Interactive comment on “Impacts of land use change and climate variations on annual inflow into Miyun Reservoir, Beijing, China” by J. K. Zheng et al.

Dear referee #1, Thanks a lot for your comments and proposals. According to Specific Comments, the replies were as followed.

Fig. 3. Figure 8.

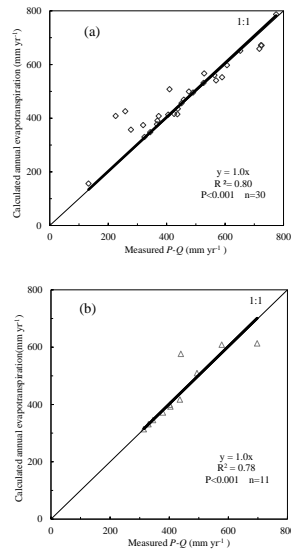
line 11-15, climate change in the future should be considered in designing watershed management strategies. For example, according to IPCC, the trends of precipitation and air temperature are required in designing water resource supply and allocation. "groundwater withdrawal" was replaced by "drinking water management". Figure 1, as the table above, latitude and longitude of 7 meteorological stations were described. Figure 2 (should be Figure 3), the reason lie in the paragraph under the table of this document. Figure 3 (should be Figure 4), four categories were used in the Figure. Reasons as followed. First, others including water area, residential area, and bare area, account for very small proportion of total area. Second, the manuscript focus on Ep. Others including water area, residential area, and bare area account for very small proportion of Total Ep. Figure 9, "the dashed line" have been replaced by "the thin line". "the solid line" have been replaced by "the bold line". "measured evapotranspiration" have been deleted.
